# ADDISON AIRPORT

DRAINAGE IMPROVEMENTS  
DRAINAGE LINE "B"  
DRAINAGE PLAN AND PROFILES-STA.7+30 TO STA.15+75

SHEET 6  
DATE: SEPT. 1991

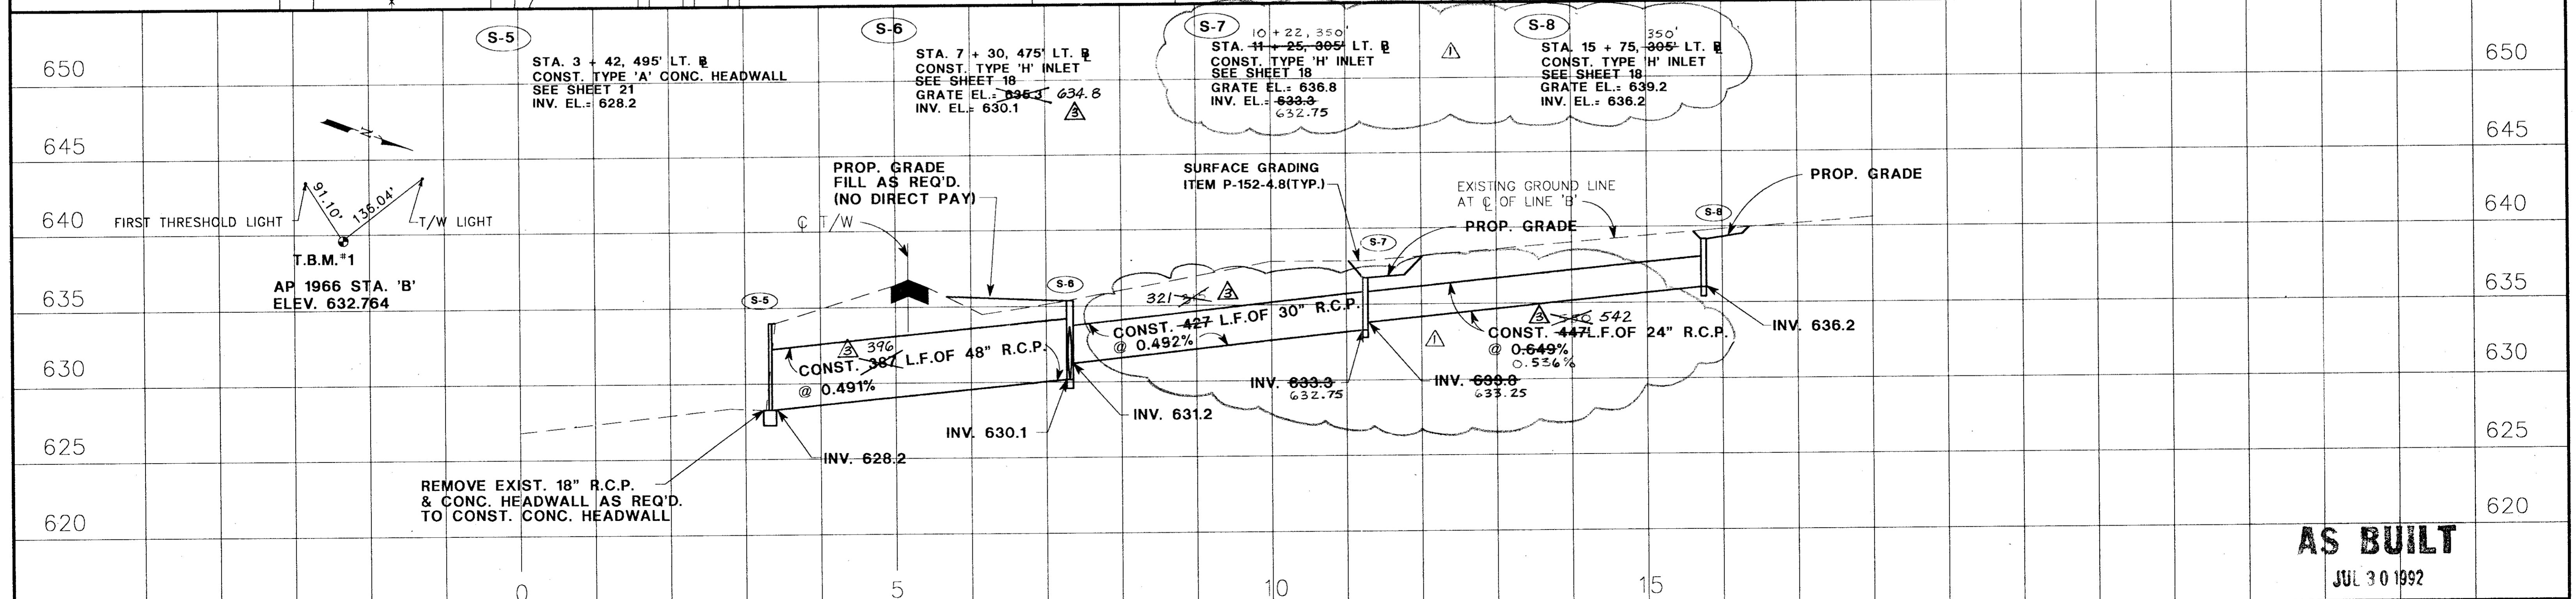
DESIGN: R.C.R.	A.L.P. NO: 3-48-0063-03-91	2-3-92	MOVE LINE B FROM 70' TO 200' FROM CENTERLINE OF RUNWAY 15-33	J.R.H.
DRAWN: M.J.G.	S.P. NO:	6-30-91	FIELD CHANGE	J.R.H.
CHECKED: D.W.P.	JOB NO: Y8024.22	7-30-92	AS BUILT	J.R.H.
SCALE: 1" = 100' HORIZ. 1" = 5' VERT.	Date	Revisions	By
